Access Compliance Report

Public Rights-of-Way

Intersection ID: 45506	Main Street: WADE_ARDREY_RD	Cross Street: WHEATFIELD_RD	Location: SW
ADA ID: F5A346ABC552	Ramp Type: PerpDiag	Initial Pass/Fail: Fail	Overall Compliance: No
Severity Score: 13.75			
Codes/Mitigation Info/Possible Solution		Field Measurements/Component Compliance

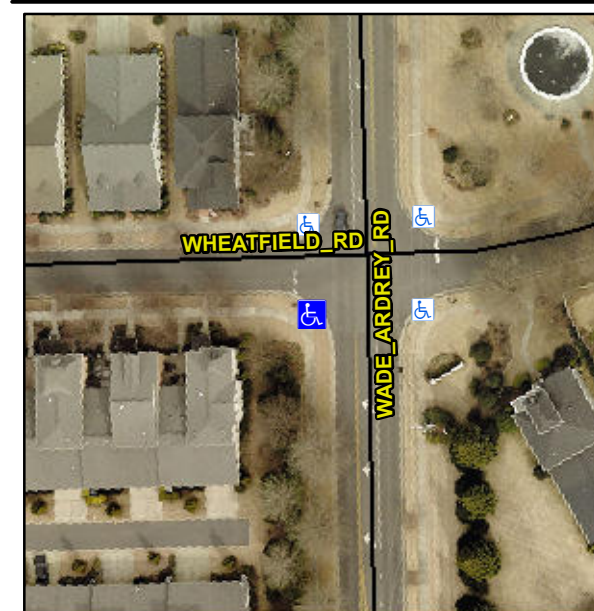
Not Found, R304.2.2, R304.5.3

Compliance	Description	Data	Compliance	Description	Data
N/A	Ramp Length (in)	96.0	No	Ramp Slope (%)	10.4
Yes	Ramp Width (in)	48.0	No	Ramp XSlope (%)	3.9
N/A	Flare Type LT	N/A	N/A	Flare Type RT	N/A
N/A	Flare Slope LT (%)	N/A	N/A	Flare Slope RT (%)	N/A
N/A	Flare Traversable LT?	N/A	N/A	Flare Traversable RT?	N/A
N/A	Landing Length (in)	N/A	N/A	DWS Provided?	N/A
N/A	Landing Width (in)	N/A	N/A	DWS Contrast?	N/A
N/A	Landing Slope (%)	N/A	N/A	DWS Length (in)	N/A
N/A	Landing X Slope (%)	N/A	N/A	DWS Full Width?	N/A
N/A	Landing Curb? (Y/N)	N/A	N/A	DWS Offset (in)	N/A
N/A	Shared Landing?	N/A			
N/A	Gutter Ponding?	N/A	N/A	Gutter Slope (%)	N/A
N/A	Gutter Lip Ht (in)	N/A	N/A	Gutter X Slope (%)	N/A
N/A	Painted X Walk1?	No	N/A	Painted X Walk2?	No
	X Walk 1 Direction	To E		X Walk 2 Direction	To N
N/A	X Walk 1 Width (in)	N/A	N/A	X Walk 2 Width (in)	N/A
	X Walk 1 Slope (%)	3.9		X Walk 2 Slope (%)	2.1
	X Walk 1 X Slope (%)	1.2		X Walk 2 X Slope (%)	5.8

Remove & Replace Curb Ramp With Two New Directional Ramps or Equivalent.
